COUNCIL SUPPLEMENTARY REPORT

SYDNEY SOUTH PLANNING PANEL

PPSSSH-122, otherwise referred to DA-741/2022, seeks approval to undertake the following works at No 149 Orchard Road in Chester Hill:

2.4. Option D – New Connection from Pit 2 to Pit CO8

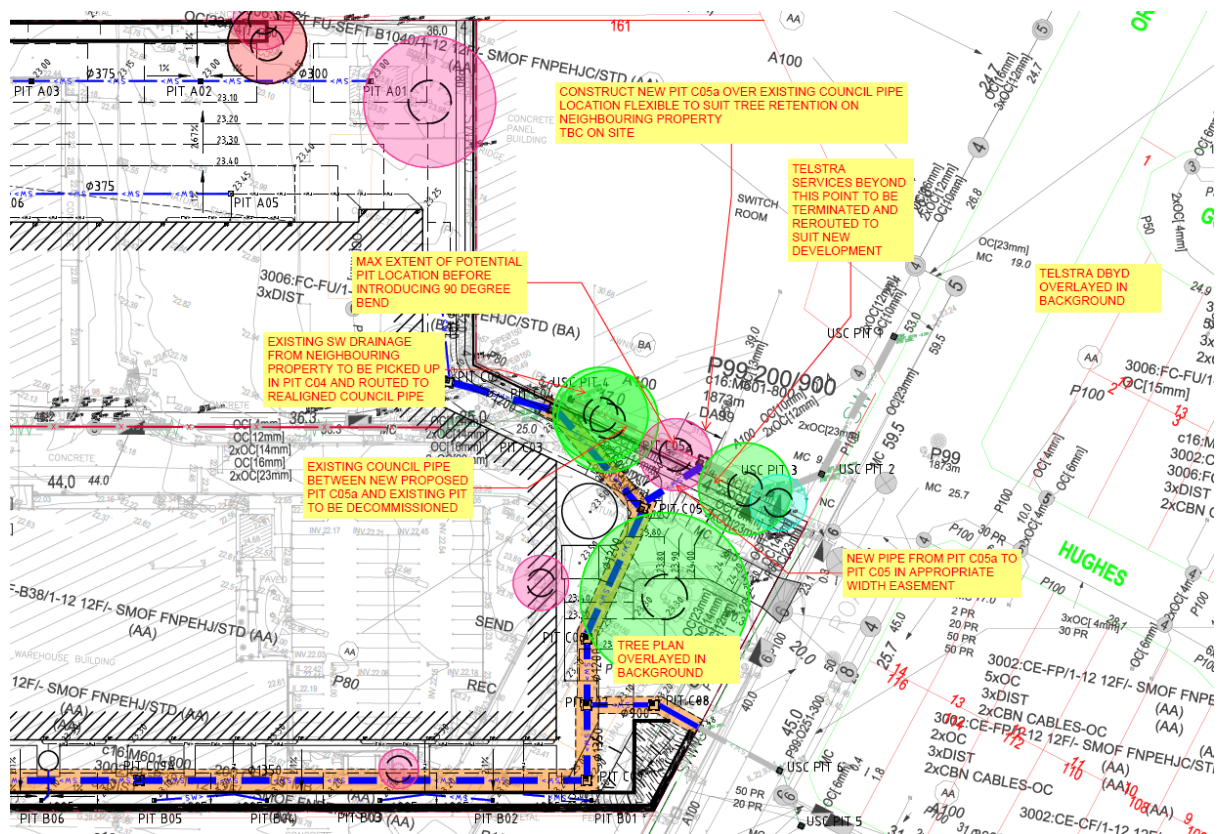
At the meeting of 28 September 2023, Council recommended an alternative design solution where a direct connection would be created between Pit 2 to Pit CO8. The pipe would run along the Orchard Road road reserve and avoid the Telstra pit. In principal, this design would eliminate the U-turn bend at Pit 4 and Pit CO4.

However, concerns were raised by the Applicant regarding extensive works on public land and the unknown hydrological capacity at Pit 4.

It was agreed that there were insufficient information and time to explore this option.
